**RE: North Country Environmental Services, Inc.
Lined Landfill Facility – Bethlehem, New Hampshire
Response to NHDES Letter of Deficiency Items #2, #3, #4 & #5**

Re: Action Item 3a Evaluation
Letter of Deficiency No. SWMB 24-006
North Country Environmental Services, Inc. Landfill
Bethlehem, NH

**Letter of Deficiency No. SWMB 24-006
Partial Response – Action Items 4 & 5**

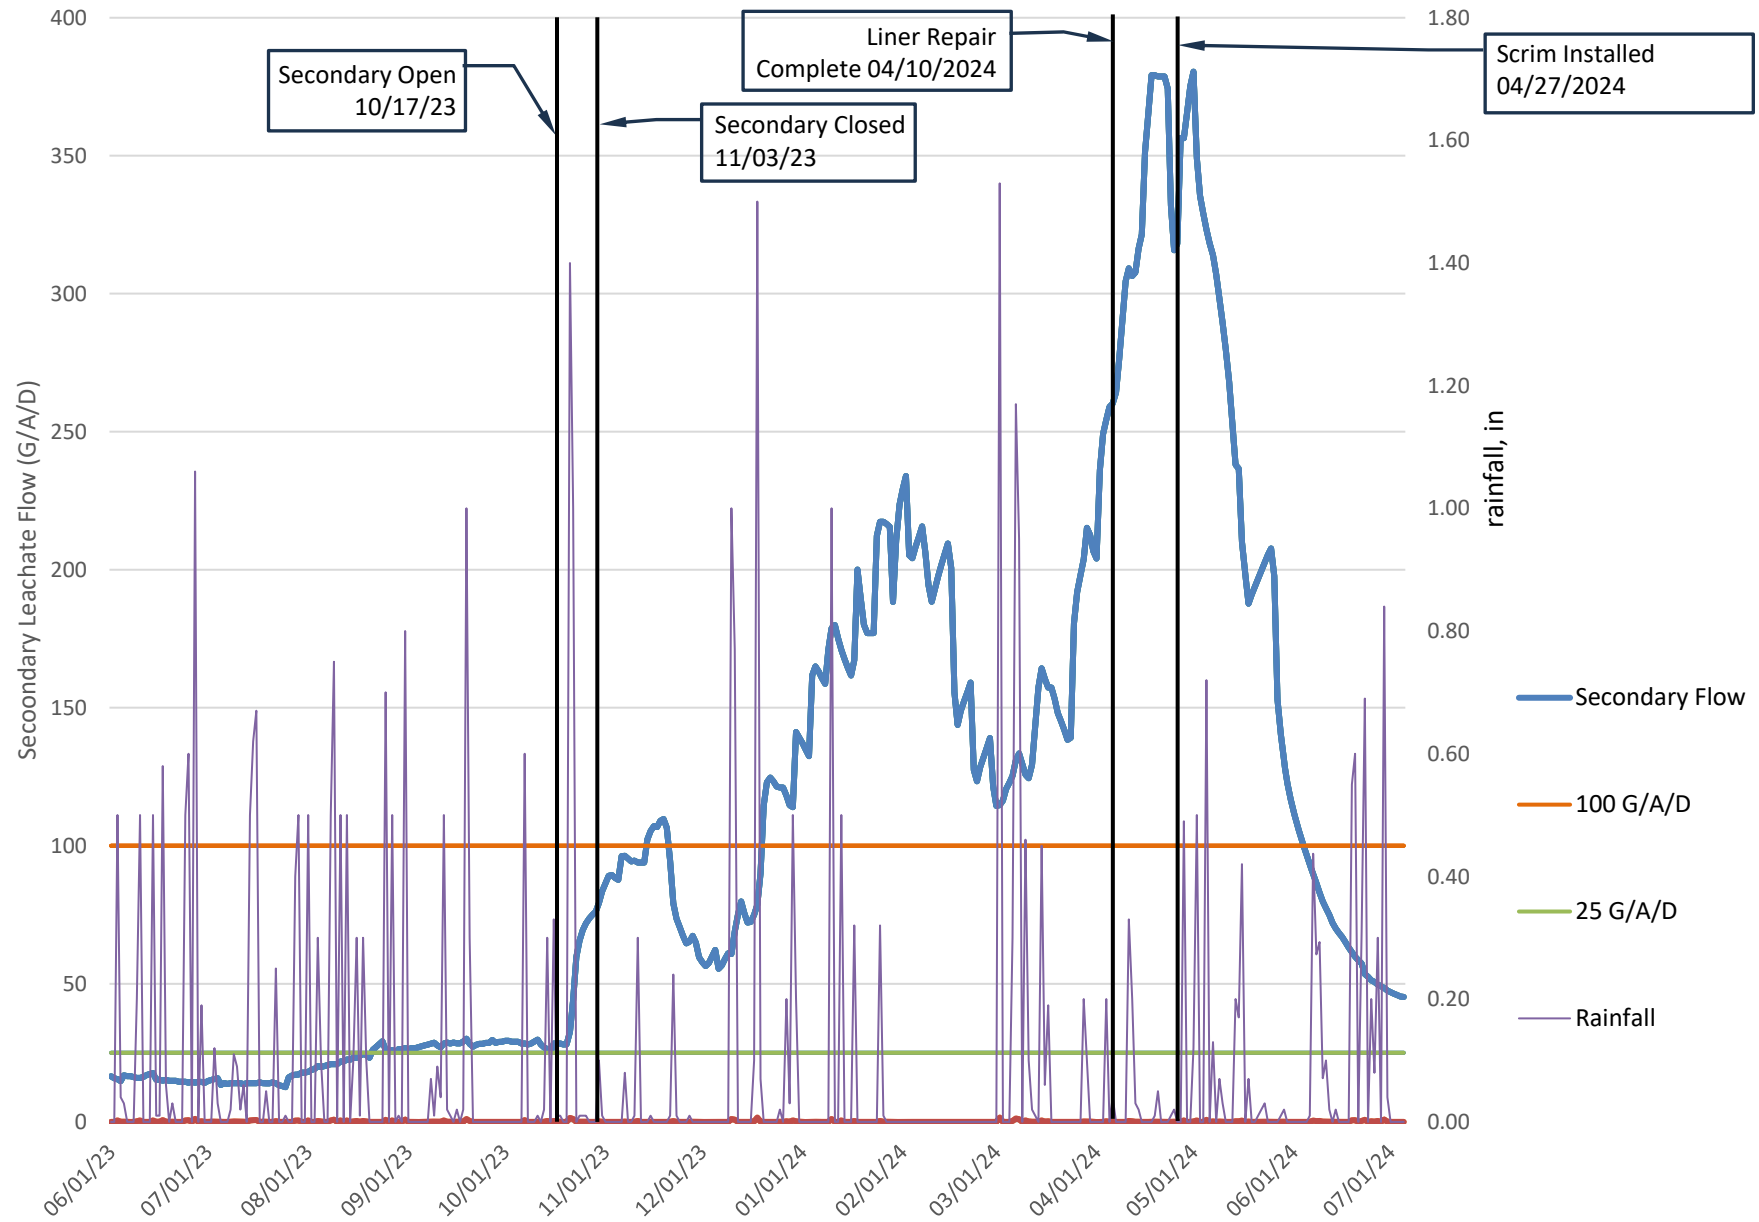
construction disturbance and the rapid drainage from the exposed 3H:1V slope area, not all stormwater runoff gets into the collection system at the bottom of the new slope. A portion flows to the north and collects over the low point of the cell, which is within the Pump Station 2 drainage footprint. The enclosed Secondary Liner Area Figure highlights the 220-foot tie-in location.
